TOWN OF GLASTONBURY

GL-2019-28

GRANGE POOL REPAIRS

ADDENDUM NO. 1

SP0.0

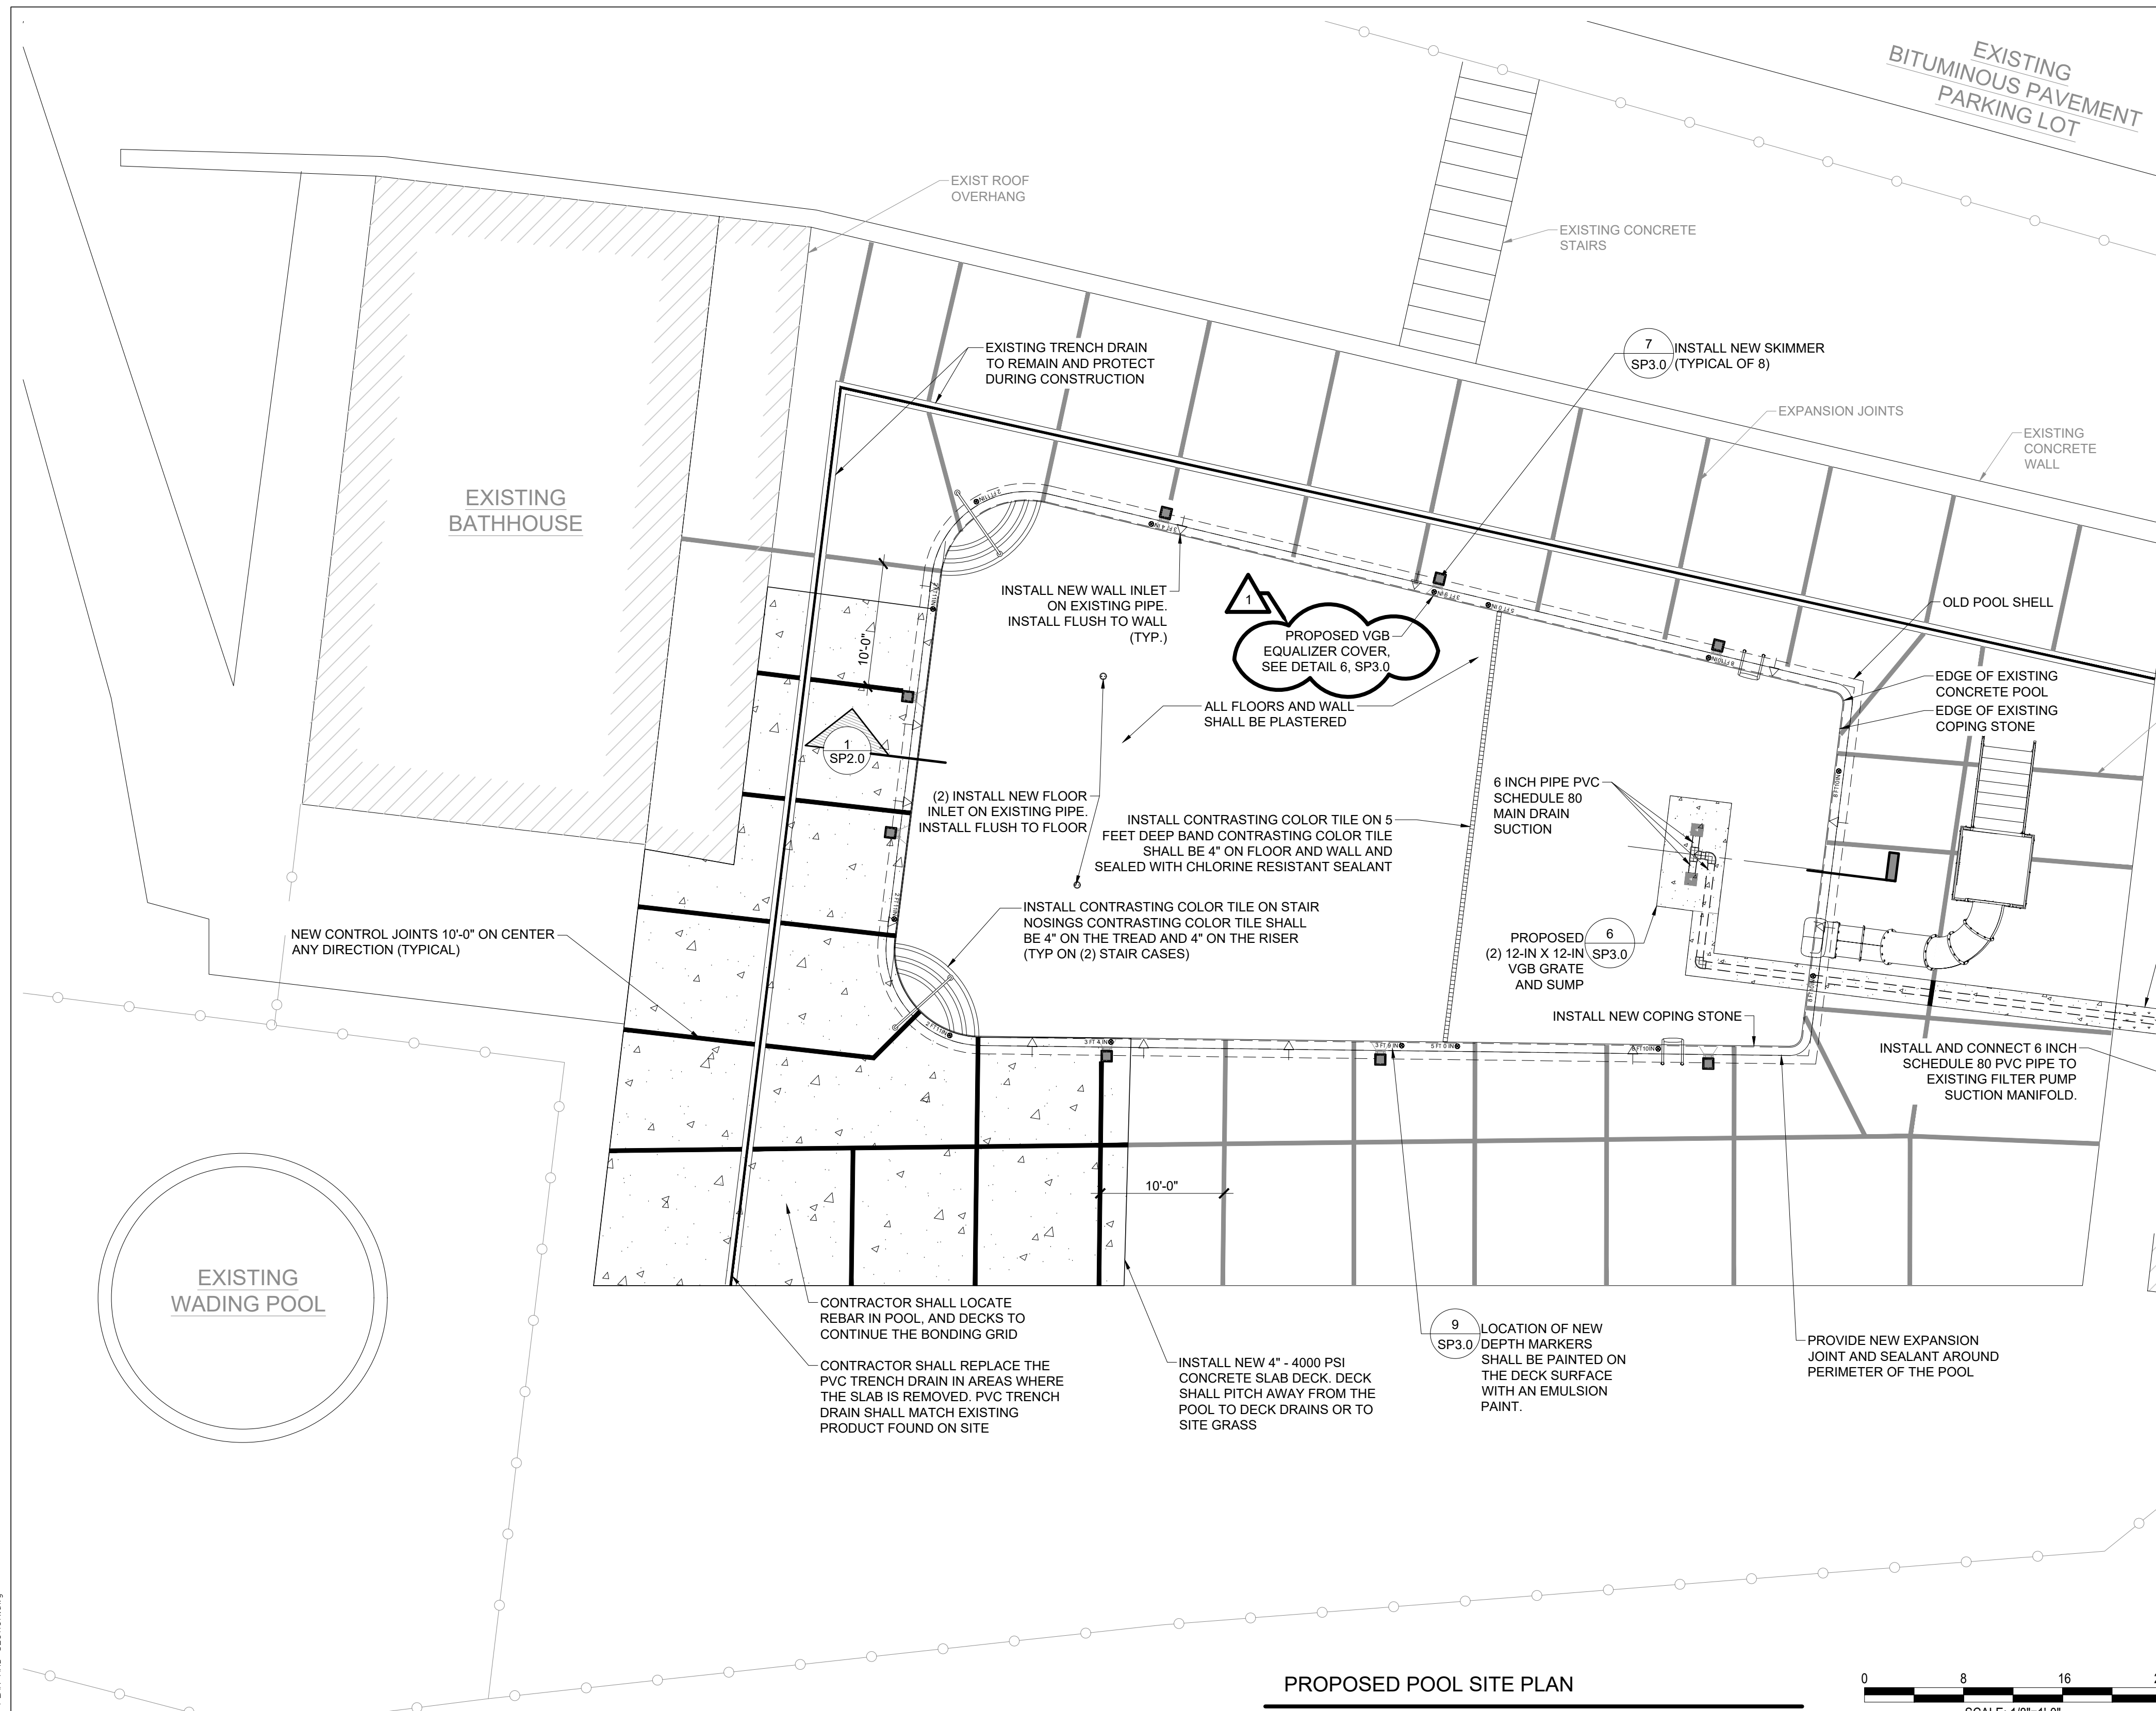
During the pre-bid meeting, a question was asked about item #13, on Drawing SP 0.0, under “Structural notes and Restrictions”. The note referred to installation of a dewatering system. We had stated this wouldn’t apply to this project, and we would be removing it from the plans. The attached drawings in this Addendum (SP 0.0), clarifies this, in that it was “removed”.

Sheet Number:
SP2.0

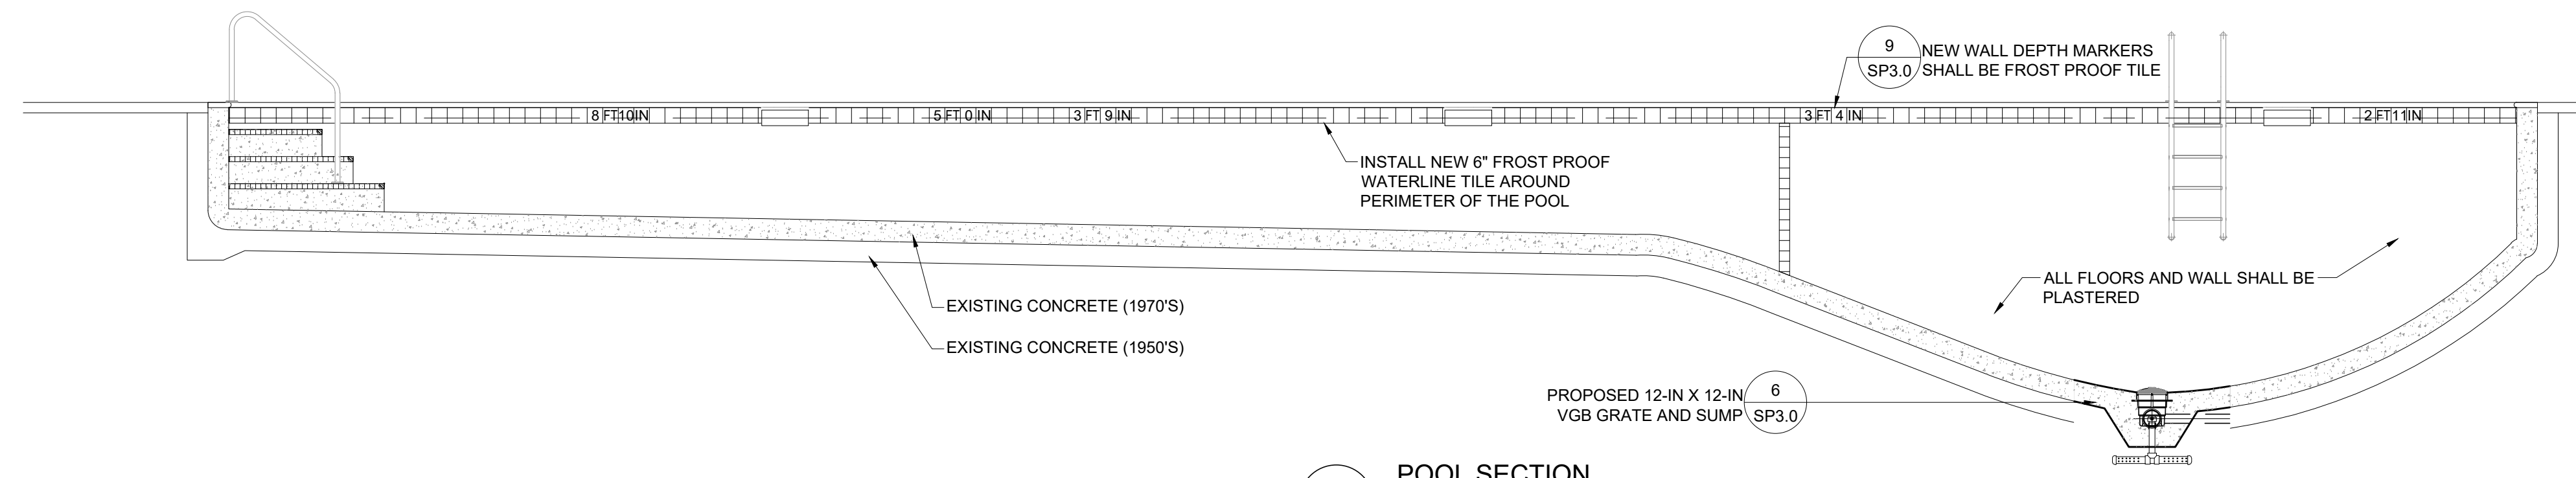
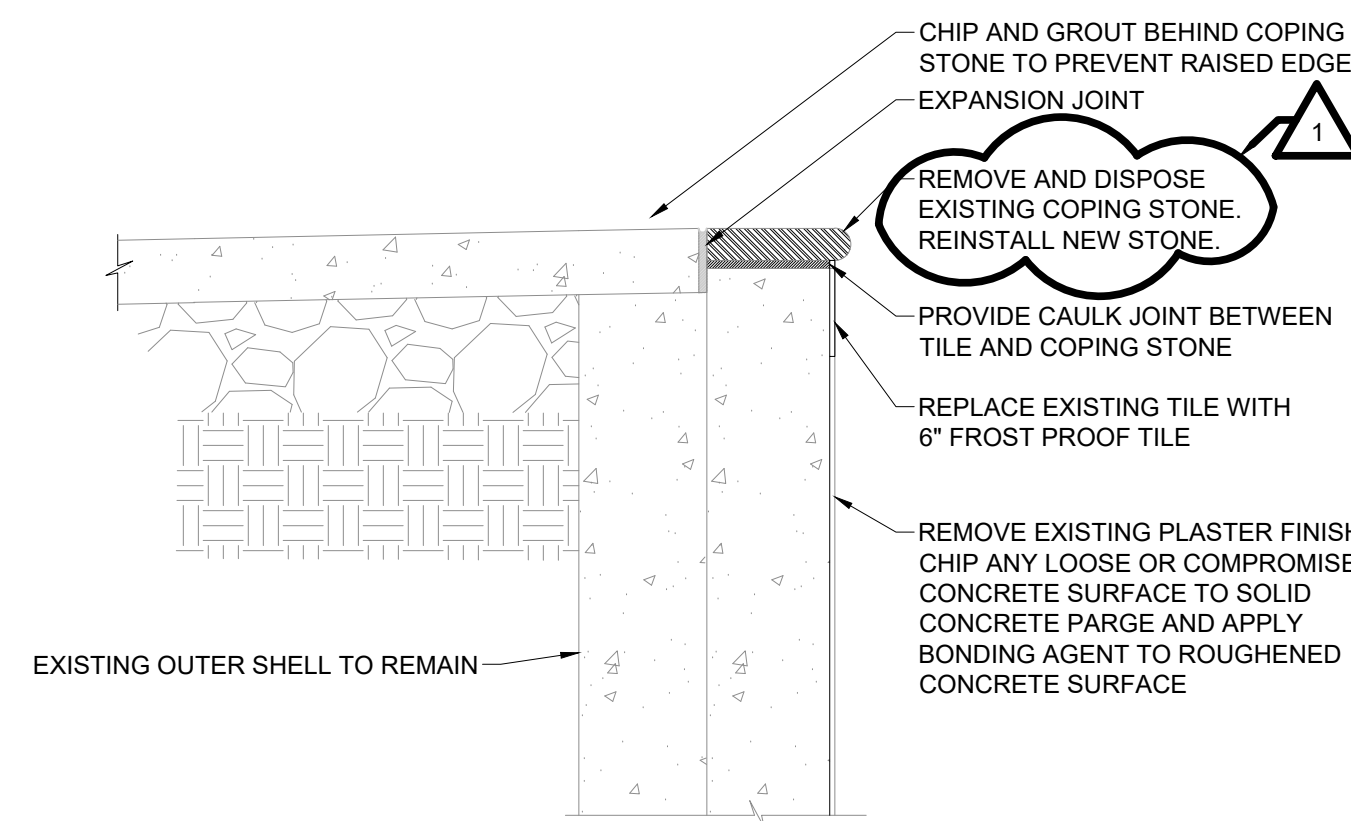
Question 9: *Do we bring back all main lines back to the filter room?*

Answer: Yes, as identified on SP 2.0

1 POOL WALL AND COPING
SCALE: NOT TO SCALE

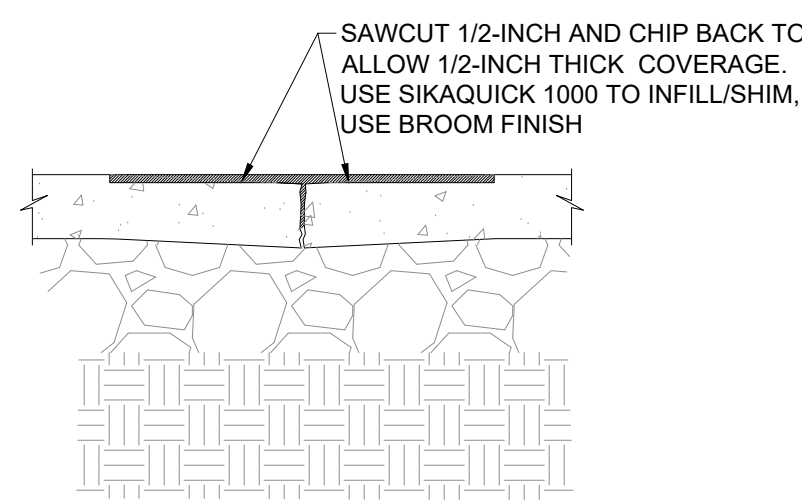
Question 5: *Are we to replace all the coping with new coping?*

Question 6: *Can we put the depth markers in the coping?*

Question 7: *Coping – is it precast coping or is brick coping acceptable which is preferred?*

Answer: Yes.

Answer: Yes, but shall be slip resistant.

Answer: Precast Coping is basis of design. Brick is not acceptable.
